RE: Response to Data Request #1 for the Gates 500 kV Dynamic Reactive Support Project

**LSPGC Gates Dynamic Reactive Support Project (A. 21-02-018)
 Energy Division Data Request #1 Date March 25, 2021
 LSPGC Response #1 Date April 15, 2021**

**Figure 3-3
STATCOM Substation Diagram**

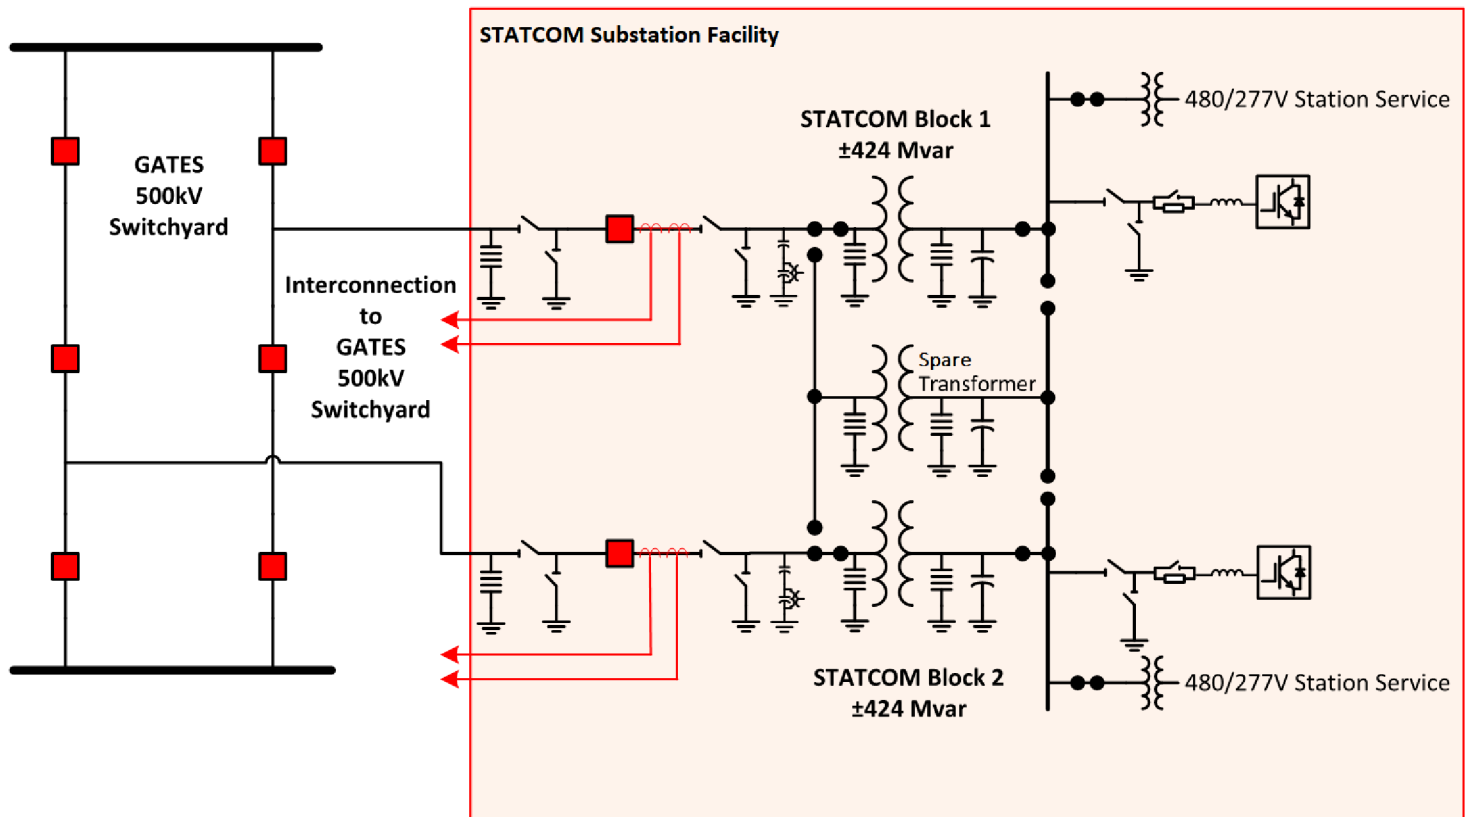
Request No.	DATA REQUEST	LSPGC RESPONSE
9	<p>PEA Figure 3-3. Provide narrative that walks the reader through the system shown in PEA Figure 3-3. E.g., what do the red boxes, red arrows, etc., represent and what functions do they serve, and what process occurs at each facility in the STATCOM block. Also, revise the figure to point out some of the main ancillary components identified in the bullet lists on PEA pages 3.0-4 and 3.0-5.</p>	<p>See attached revised Figure 3-3, STATCOM Substation Diagram that illustrates the electrical integration of the proposed STATCOM Substation facility and the existing PG&E Gates Substation. The main components of the electrical functionality of facilities, including the transformers, STATCOM reactors, disconnect switches and circuit breakers are labeled accordingly. The red arrows on the diagram illustrate the newly stabilized 500 kV power being directed back to the PG&E Gates Substation. The following is a description of the major substation equipment and their proposed functions:</p> <ul style="list-style-type: none"> • Transformers – Electrical equipment that transforms electric current from one voltage to another. • STATCOM Reactors – Electrical equipment that removes harmonics from the electric current and smooths the current waveform. Provides for system stability. • Disconnect Switches - Electrical equipment that provides a means of isolating one piece of equipment from another. Primarily used for equipment maintenance. For the Proposed Project, the disconnect switches will be used to isolate the STATCOM Substation from the PG&E Gates Substation. • Circuit Breakers - Electrical protection device that is used to isolate equipment in the event of a system fault. Provides both safety and equipment protection.
